Test Monitoring Center

Sequence IIF Information Letter 03-2

SUBJECT: Editorial Corrections

Fig. A8.1

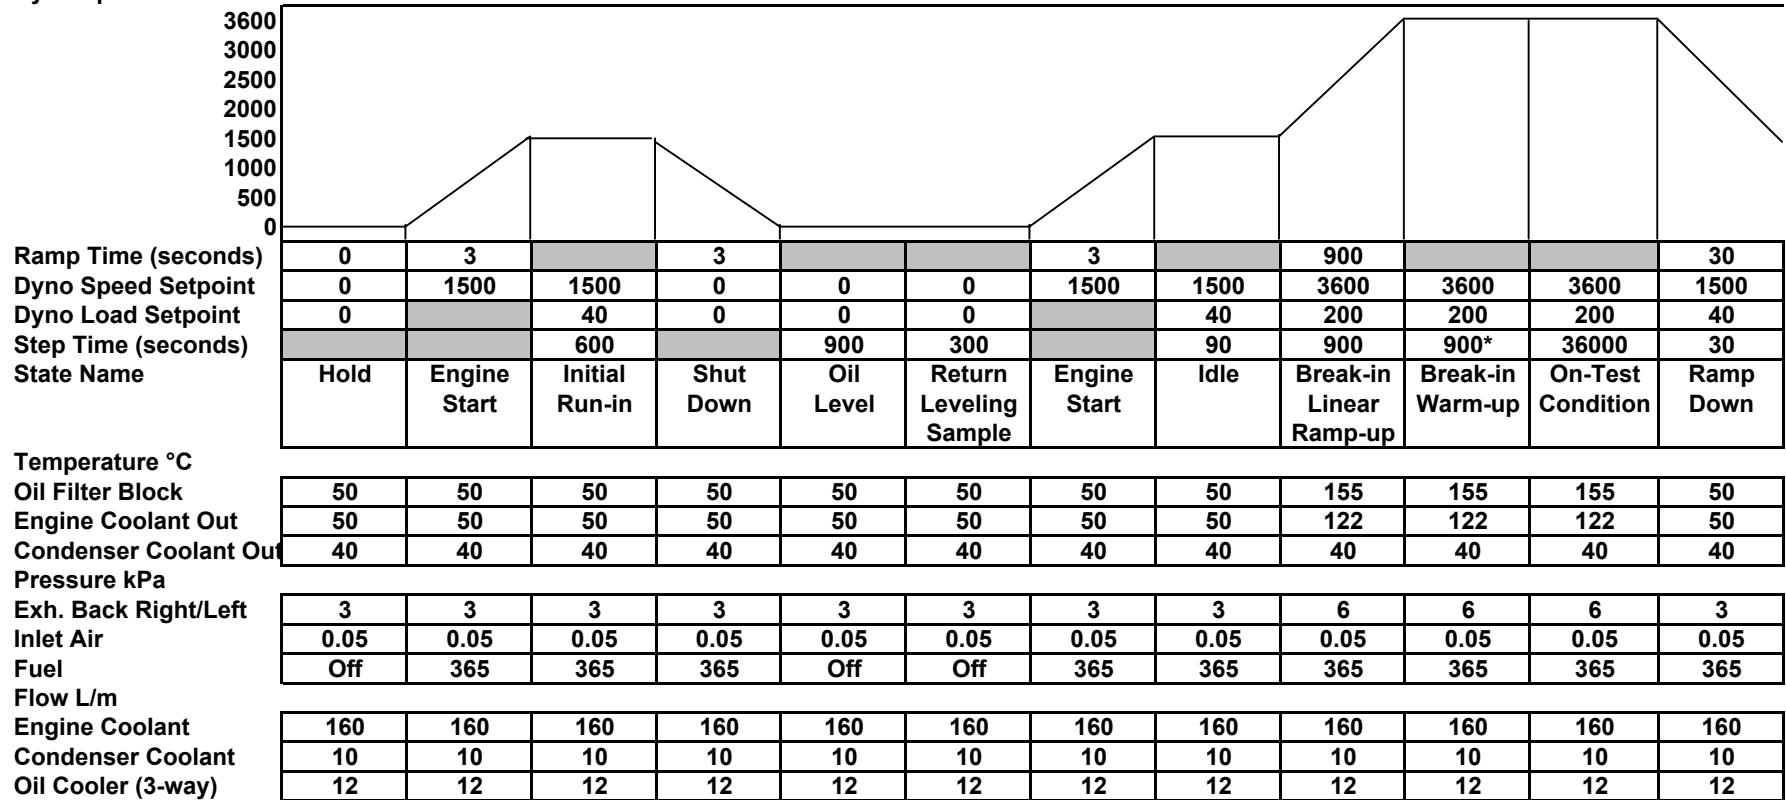
Annex A8 contains an error in Figures A8.1 and A8.2 in the Exhaust Backpressure specification shown in those figures. The old figure listed a target EBP specification of 3 kPa and the correct value is 6 kPa. Revised figures, which contain the correct information, are attached.
